# Access Compliance Report

## Public Rights-of-Way

Intersection ID: 10034320	Main Street: PERIMETER_PY	Cross Street: N/A	Location: NE
ADA ID: 2A9233DC17B7	Ramp Type: Perp	Initial Pass/Fail: Fail	Overall Compliance: No
Codes/Mitigation Info/Possible Solution		Field Measurements/Component Compliance	
Severity Score: 21.25

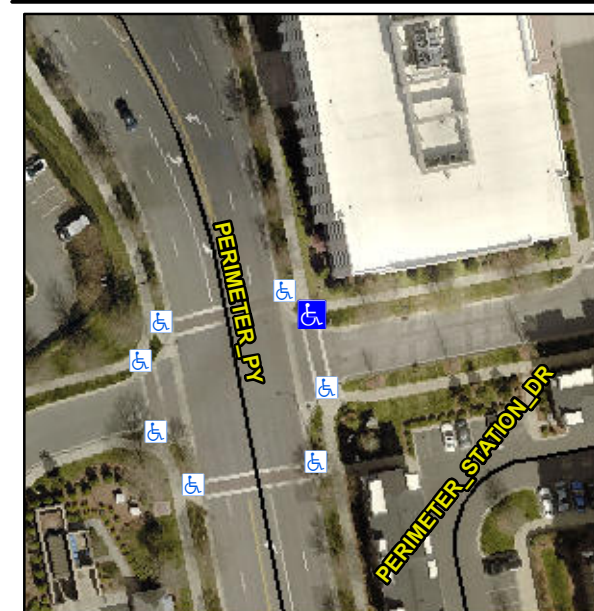
**Not Found, R304.5.1, R304.2.2**

Compliance	Description	Data	Compliance	Description	Data
N/A	Ramp Length (in)	78.0	No	Ramp Slope (%)	8.8
No	Ramp Width (in)	47.5	Yes	Ramp XSlope (%)	1.4
N/A	Flare Type LT	N/A	N/A	Flare Type RT	N/A
N/A	Flare Slope LT (%)	N/A	N/A	Flare Slope RT (%)	N/A
N/A	Flare Traversable LT?	N/A	N/A	Flare Traversable RT?	N/A
N/A	Landing Length (in)	N/A	N/A	DWS Provided?	N/A
N/A	Landing Width (in)	N/A	N/A	DWS Contrast?	N/A
N/A	Landing Slope (%)	N/A	N/A	DWS Length (in)	N/A
N/A	Landing X Slope (%)	N/A	N/A	DWS Full Width?	N/A
N/A	Landing Curb? (Y/N)	N/A	N/A	DWS Offset (in)	N/A
N/A	Shared Landing?	N/A			
N/A	Gutter Ponding?	N/A	N/A	Gutter Slope (%)	N/A
N/A	Gutter Lip Ht (in)	N/A	N/A	Gutter X Slope (%)	N/A
N/A	Painted X Walk1?	Yes	N/A	Painted X Walk2?	N/A
	X Walk 1 Direction	To S		X Walk 2 Direction	N/A
N/A	X Walk 1 Width (in)	72.0	N/A	X Walk 2 Width (in)	N/A
	X Walk 1 Slope (%)	4.1		X Walk 2 Slope (%)	N/A
	X Walk 1 X Slope (%)	1.2		X Walk 2 X Slope (%)	N/A

**Remove & Replace Entire Ramp.**
